**ADDENDUM NO. 7**

**PROJECT NO. DGS C-1101-0054 PHASE 001**

**PROJECT TITLE - Lincoln University - Renovations to Cresson Hall**

**ADDENDUM NO. 7**

SECOND FLOOR PLAN

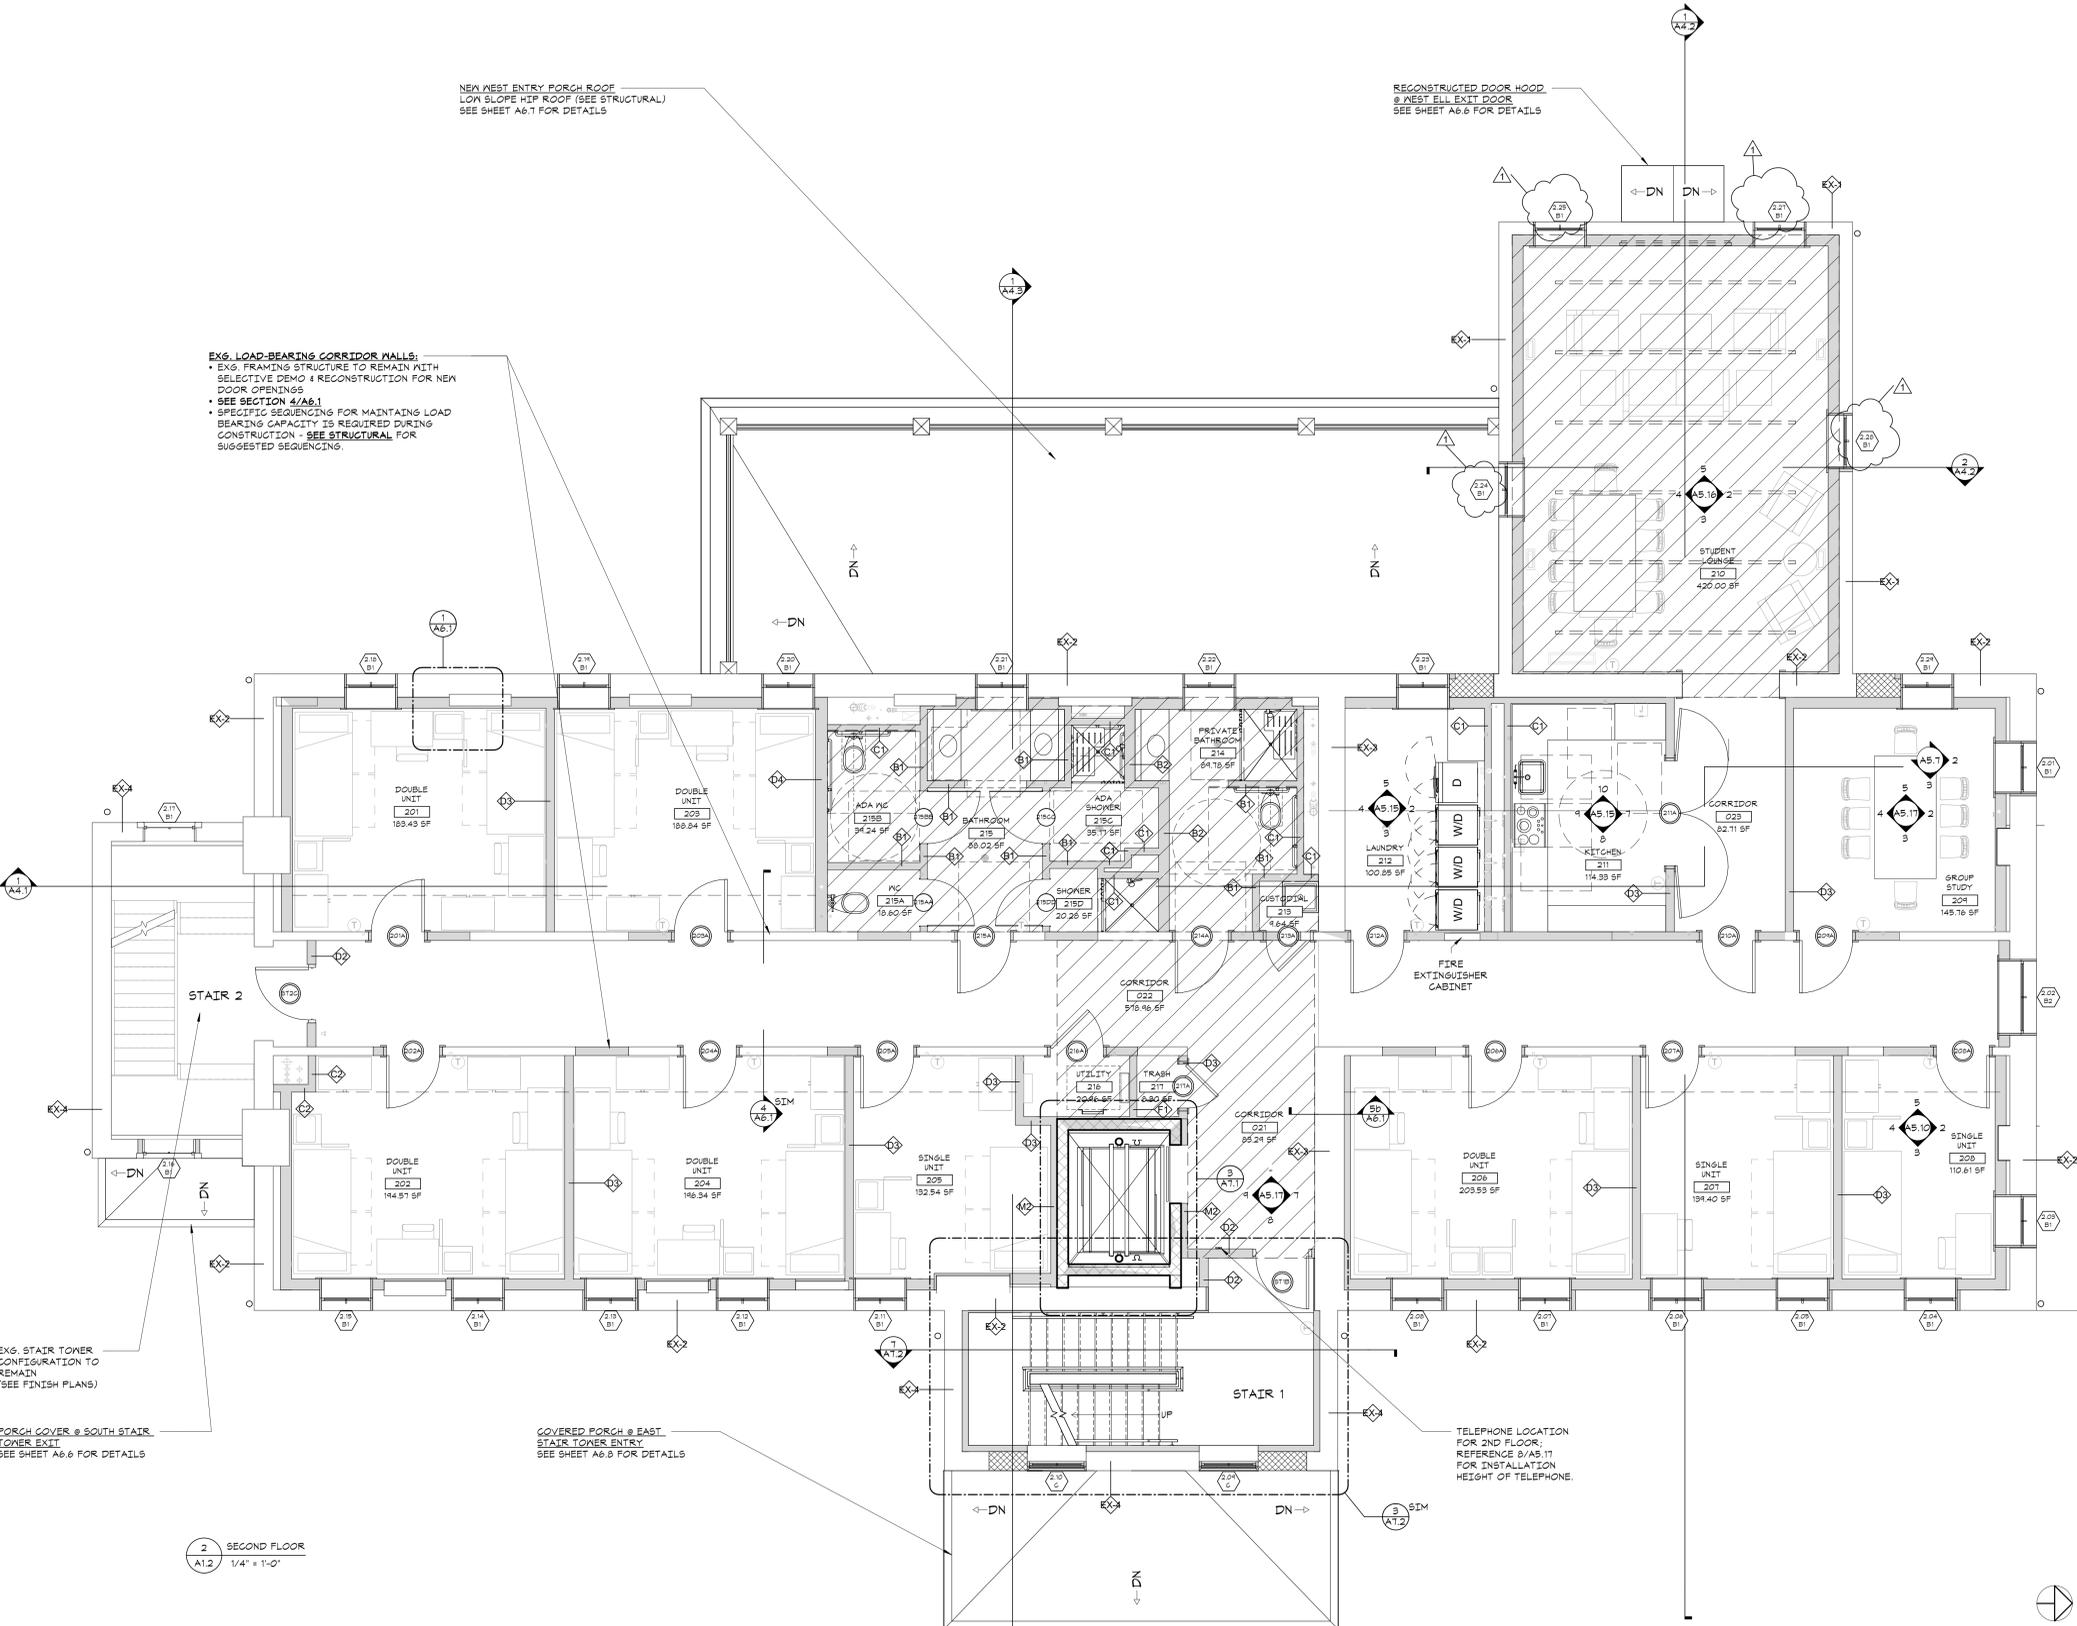
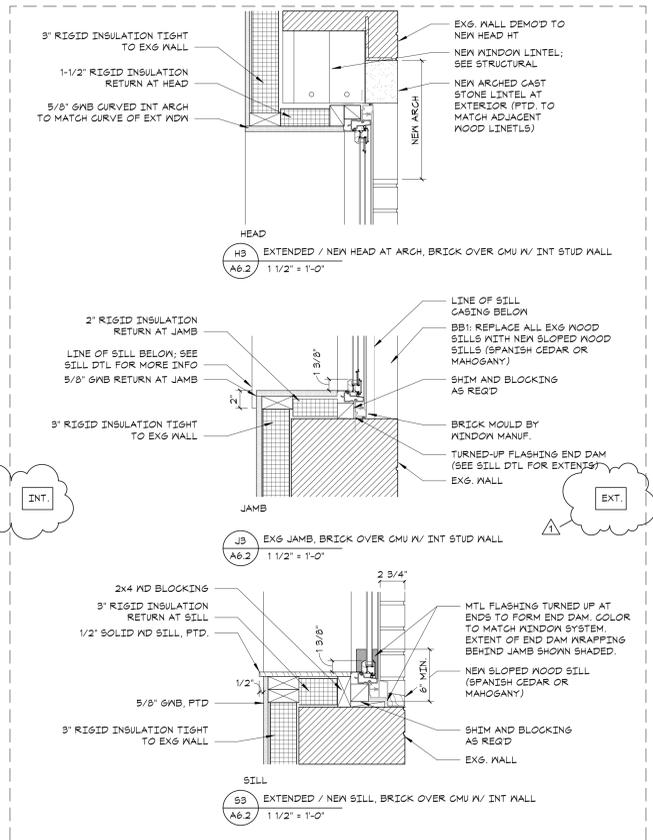
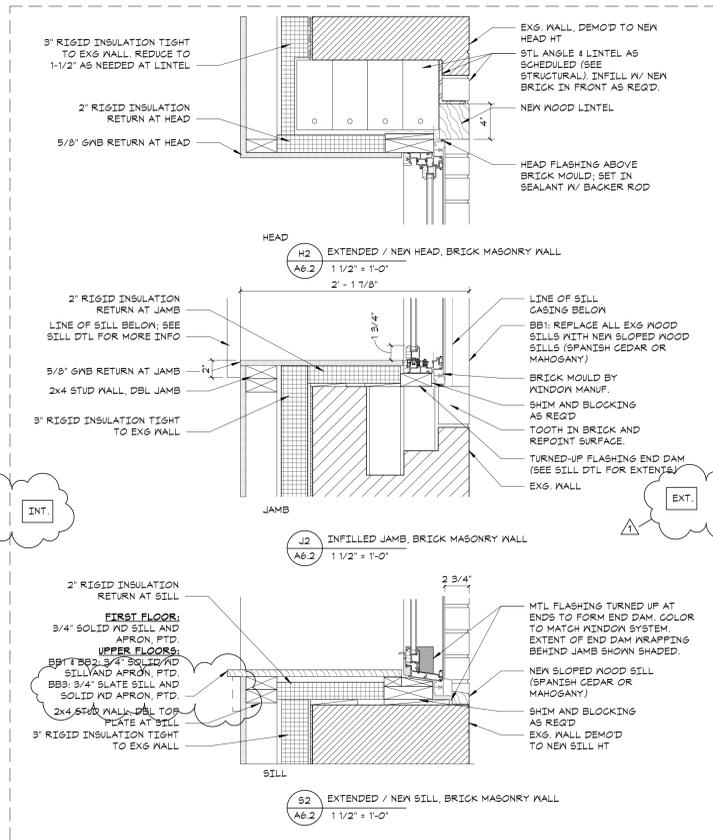
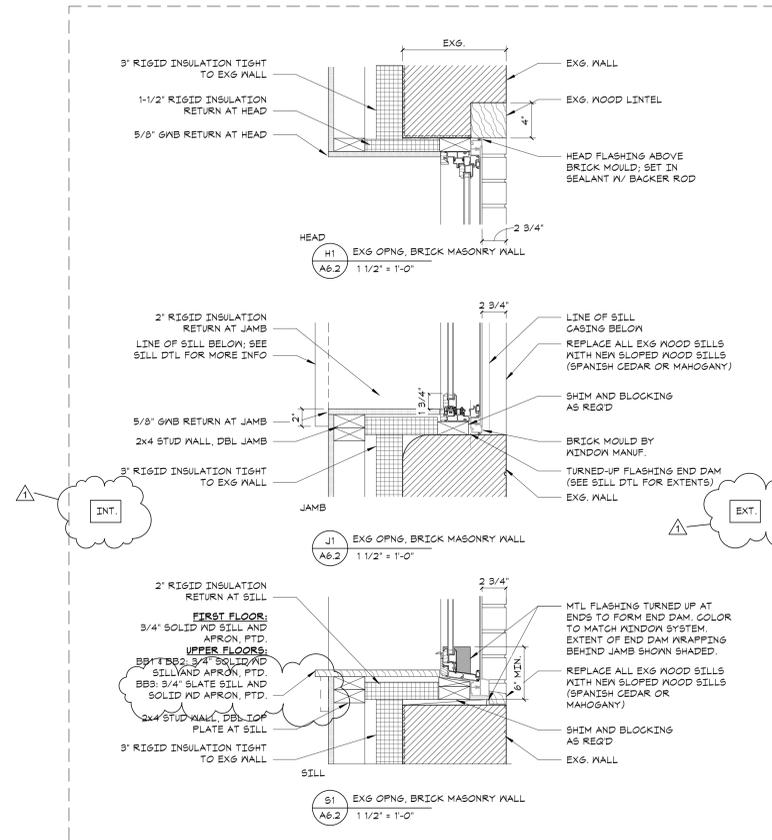
**RFI:** Drawing A6.2 shows 4 different types of window details (interior sills, exterior new and existing wood lintels). The building elevations do not show where these conditions are located or required. Can a schedule be provided?

## Item 1 – Sheet A1.2

- Plan revised to indicate window detail locations

**Response:** Sheets A1.2, A6.2, and A8.1 have been revised to provide additional detail and locations and are included in Addendum #7.

WINDOW SECTIONS

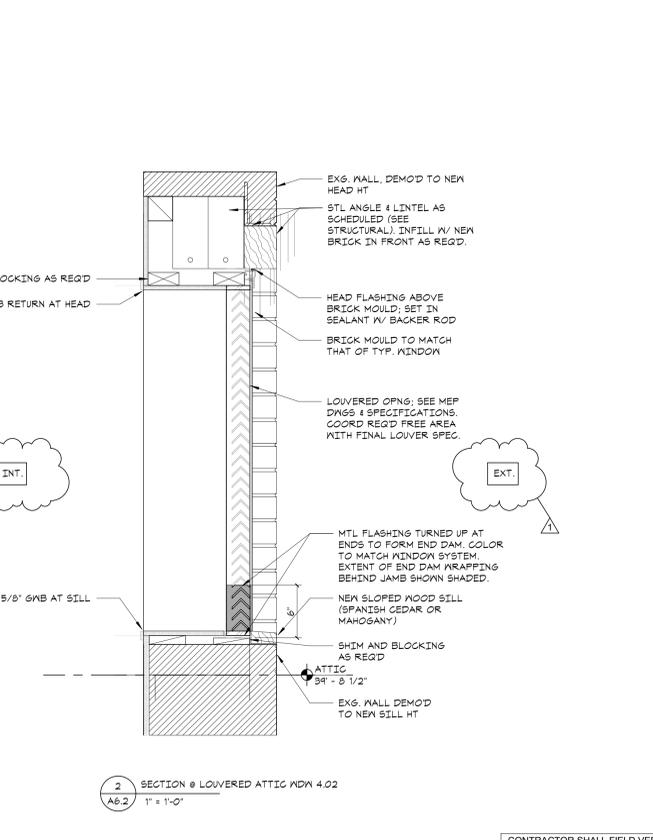
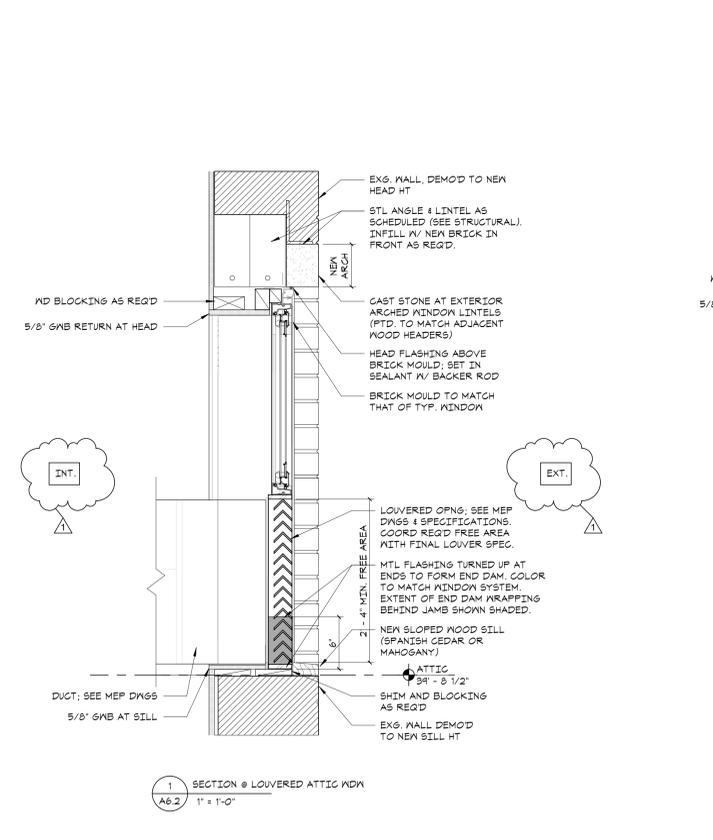
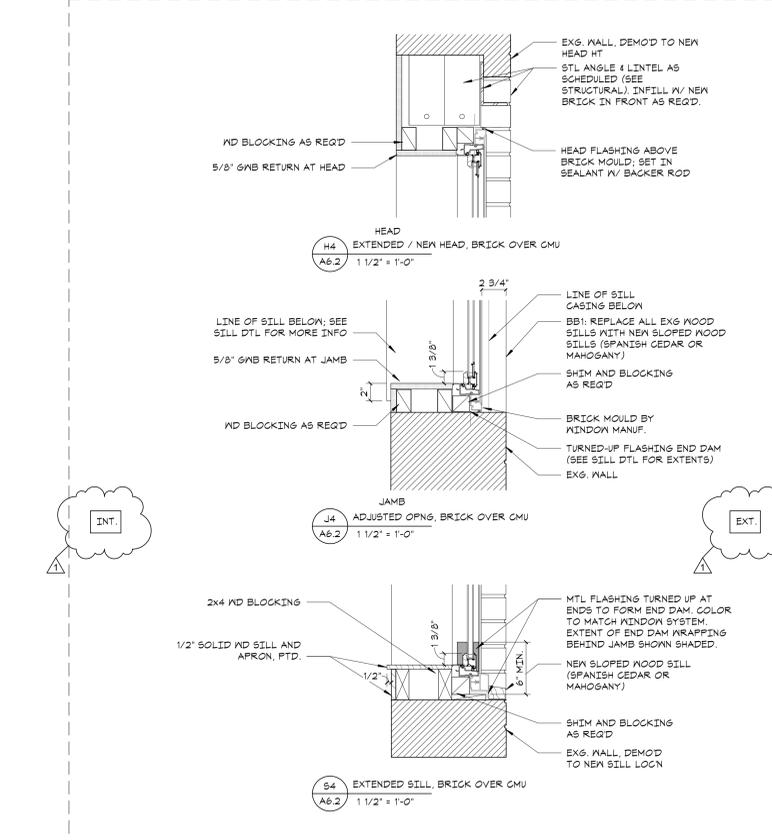
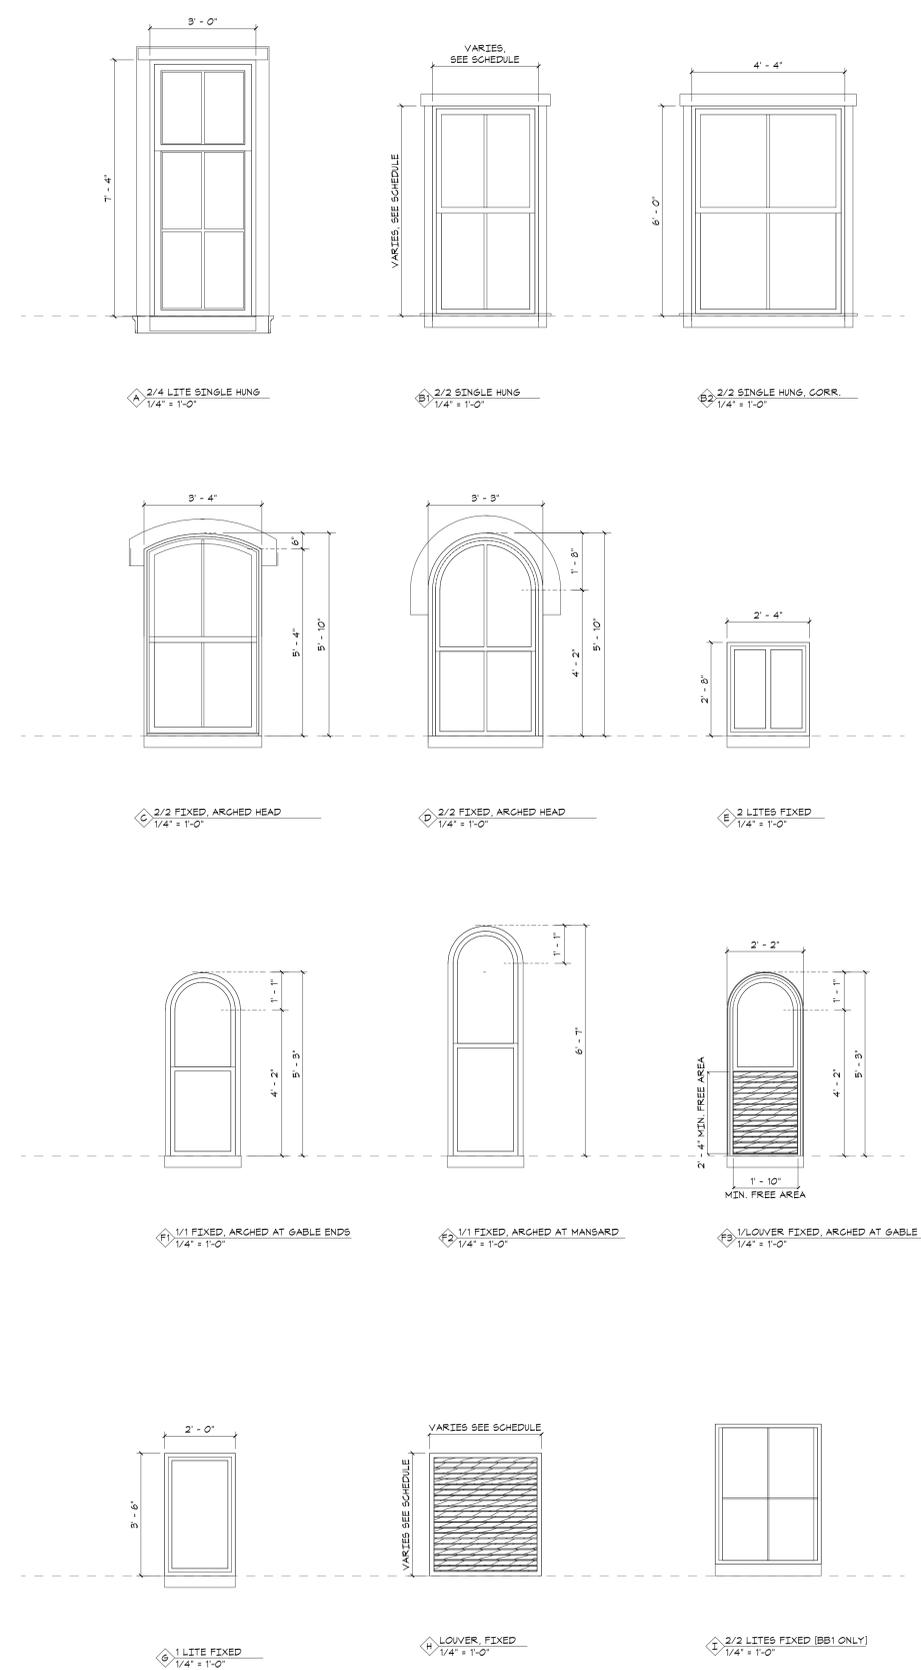
## Item 2 – Sheet A6.2

- Revised window section details
